# Florida Department of Transportation

This Project Reevaluation is submitted for your review and concurrence in accordance with the procedures of the Florida Department of Transportation. The project information is as follows:

<b>State Road No.:</b>	<b>ICTF Overpass / Eller Drive</b>
<b>Financial Project ID:</b>	<b>403984-1-32-01</b>
<b>Federal Project ID:</b>	<b>SFTL-203-R</b>
<b>County:</b>	<b>Broward County</b>
<b>Description:</b>	<b>Eller Drive from SR 5 (US 1) to McIntosh Road</b>
<b>Phase of Reevaluation:</b>	<b>Design Change</b>

**Florida Department of Transportation  
PROJECT REEVALUATION FORM**

FIGURE 2

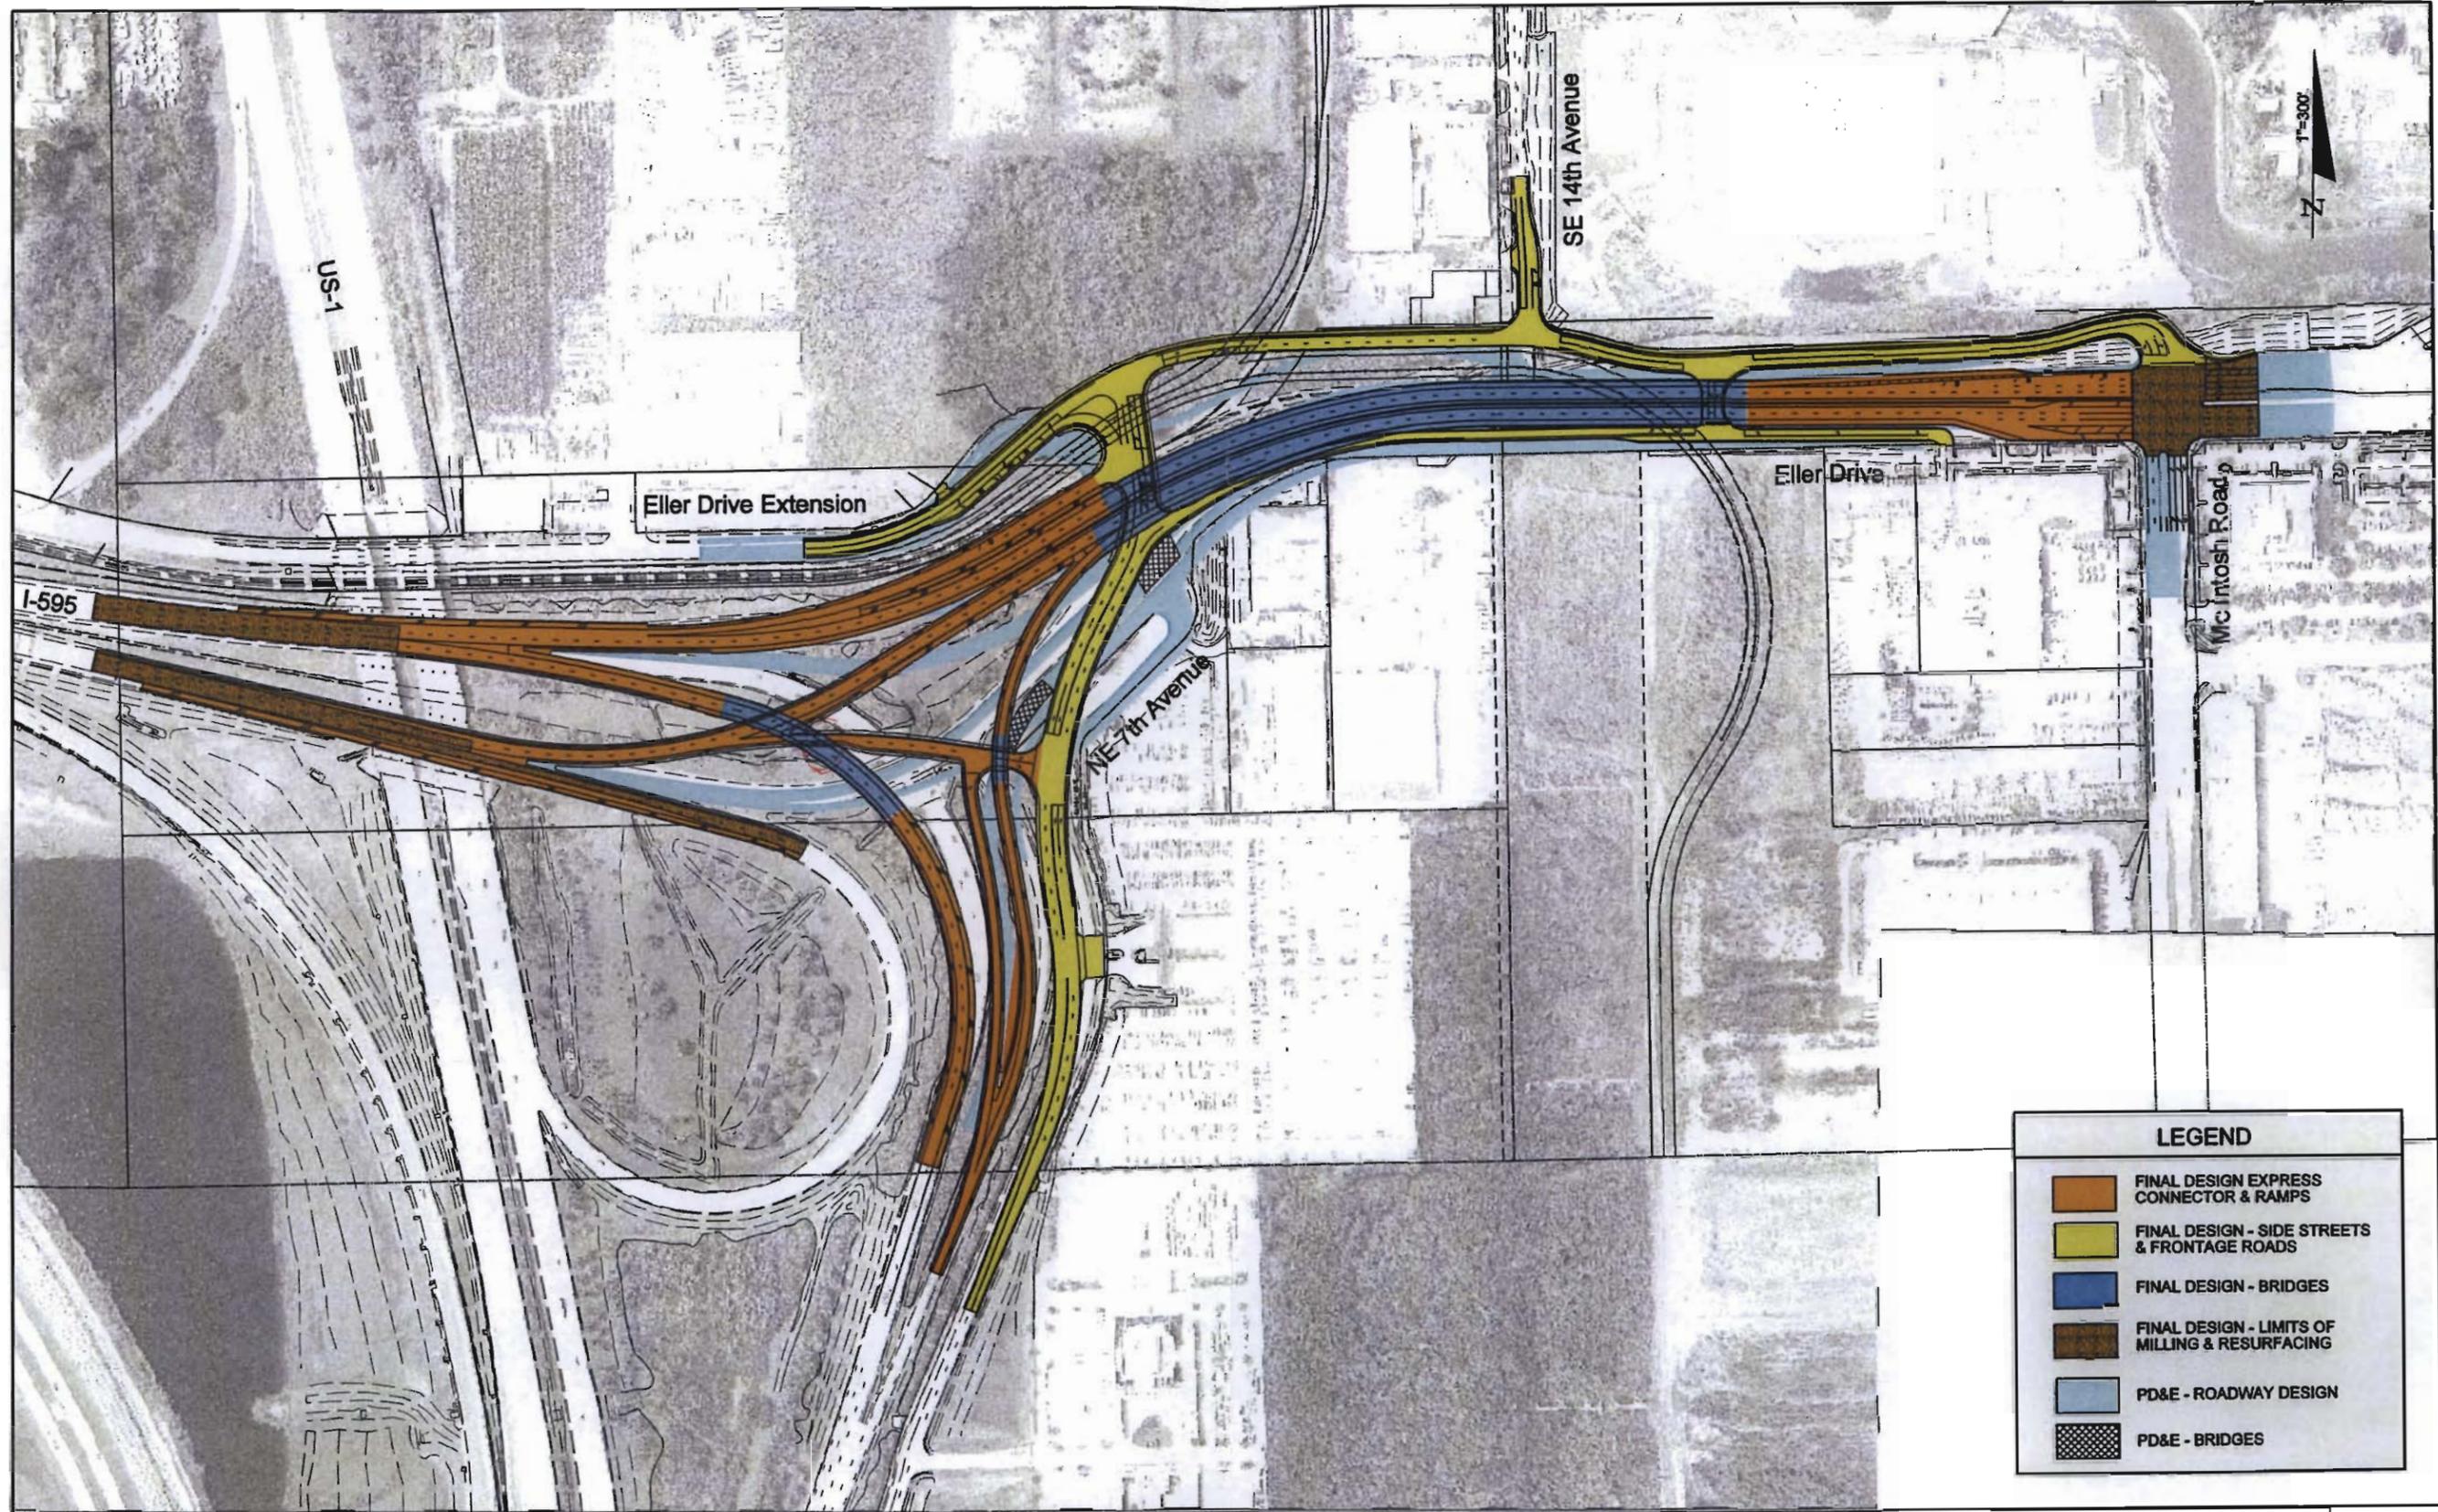
The overall shift in the approved PD&E alignment varies between 0.0' to 105.0', with the maximum shift associated with Eller Drive and NE 7 Ave intersection. The Department has been working closely with the affected property owner to coordinate the roadway expansion and development of the property.

The team has further developed the project design and has proposed the concept of a single structure to bridge between 7<sup>th</sup> and 14<sup>th</sup> Avenues, from Sta. 549+97 to Sta. 562+98. This bridging concept was evaluated and recommended by the Value Engineering Team. The original PD&E design proposed a mechanically stabilized earth (MSE) wall, and two bridge structures: one bridge was proposed over NE 7 Ave (Sta. 551+38 to Sta. 552+34), and the other one was proposed at SE 14 Ave (Sta. 558+64 to Sta. 561+47). The project team believes the maintenance of traffic during the construction phase of a single structure will maintain the flow of vehicles to the maximum extent practical, there will be a reduction in the cost of construction, and an increase in open space that will be available to be utilized as a stormwater retention pond.

FIGURE 3

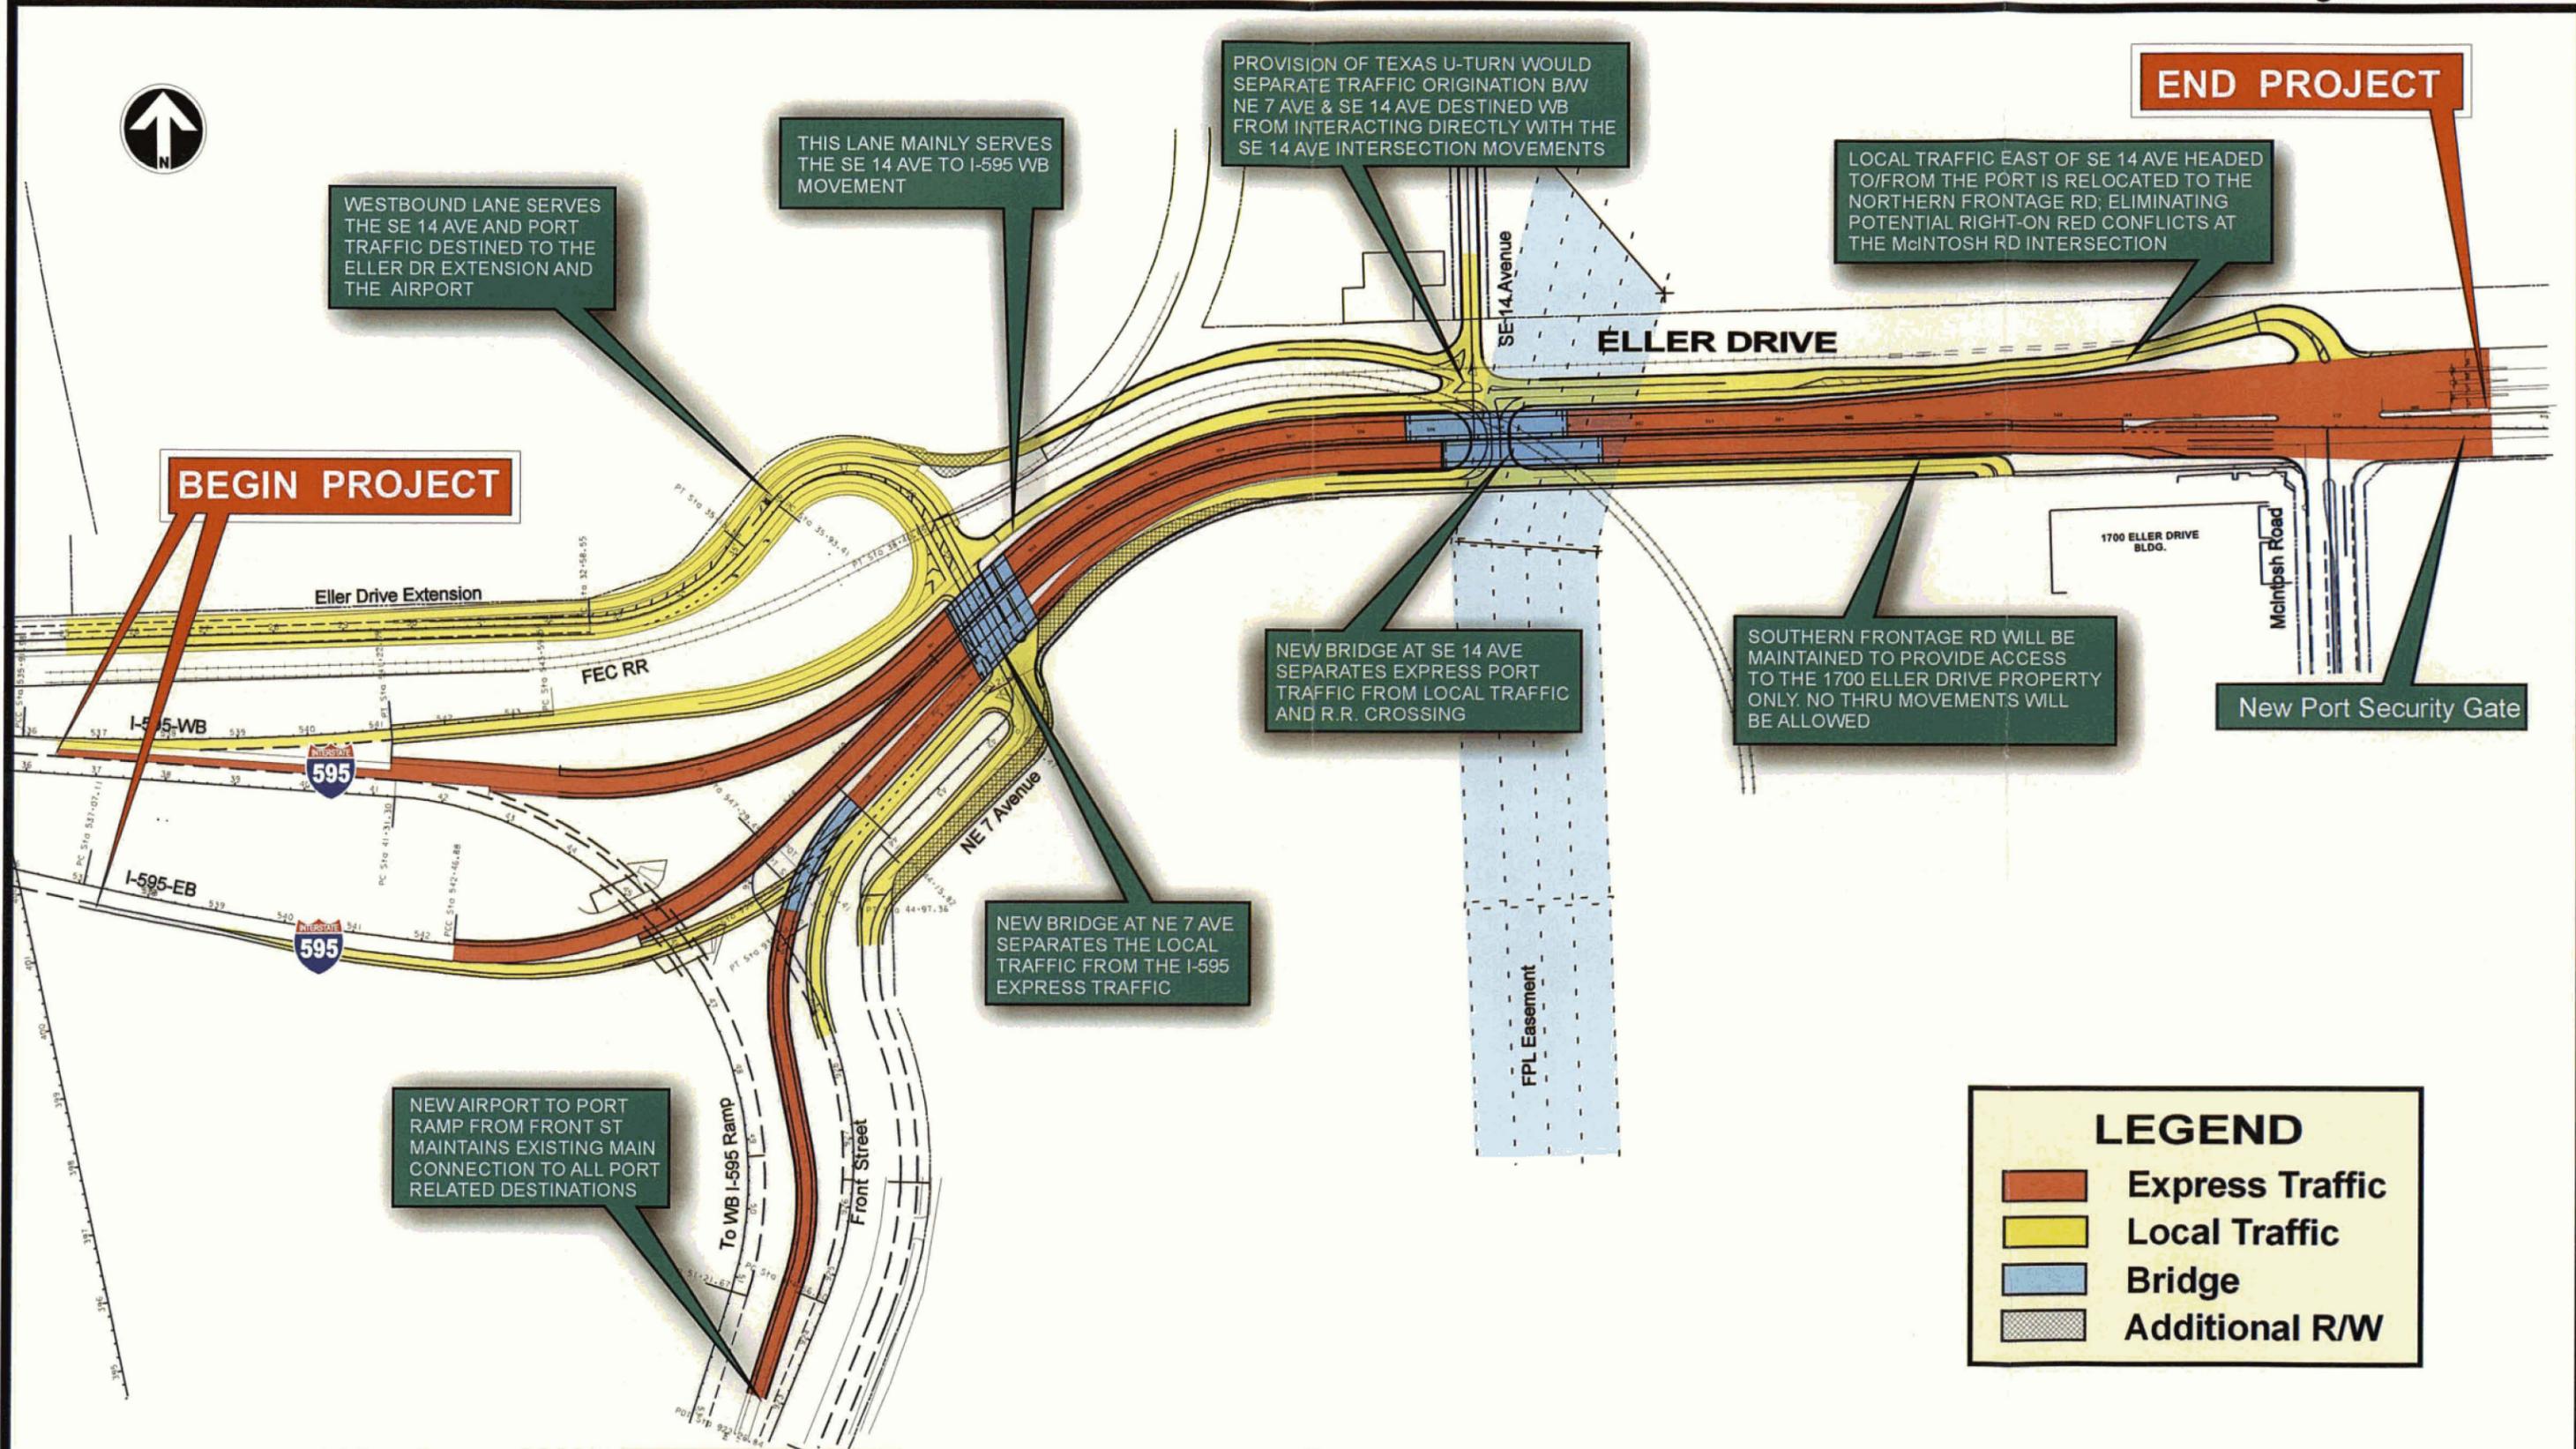
The following are other proposed design changes, (See Figure 3, EXPRESS CONNECTOR PD&E VS. DESIGN)

1. Shifted EB Eller Drive Ramp alignment so that the tangent length between the reverse curves met design criteria. This modification eliminated the need for a design variation through placement of the gore at the specified spacing from EB I-595.

2. Adding an off-ramp from I-595 EB to remove traffic from the intersection at NE 7 Avenue. The Port to Port ramp bridge length was reconfigured and shortened to reduce construction costs. As a result of the reconfiguration, the Decision Sight Distance for this exit ramp was improved and is anticipated to enhance safety.

3. Reducing limits of construction along McIntosh Road. The originally proposed milling and resurfacing along McIntosh Road will be reduced by 150.0', and will terminate closer to the Eller Drive/ McIntosh intersection.

4. Service Road South was partially relocated beneath the mainline alignment. This change reduces the right of way acquisition costs associated with the Frazer Commercial Warehouse property.

5. NE 7<sup>th</sup> avenue was realigned to provide a standard T-intersection in lieu of the non standard curved intersection.
6. WB interstate 595 ramp was relocated due to EB Eller Drive ramp relocation and to improve the EB Eller drive exit ramp to NE 7<sup>th</sup> Avenue.

7. The realignment of the EB Eller Drive mainline required the milling and resurfacing of the mainline under SR-5/US-1 for proper gore spacing and markings.

8. Service Road North was relocated to the north right of way line to better utilize all of the existing right of way. This change improved the rail road track alignment and eliminated one crossing with Service Road North. The intersection of the North Service/South Service /SE14th Avenue was improved by eliminating many of the traffic train conflicts, thereby enhancing safety and improving mobility.
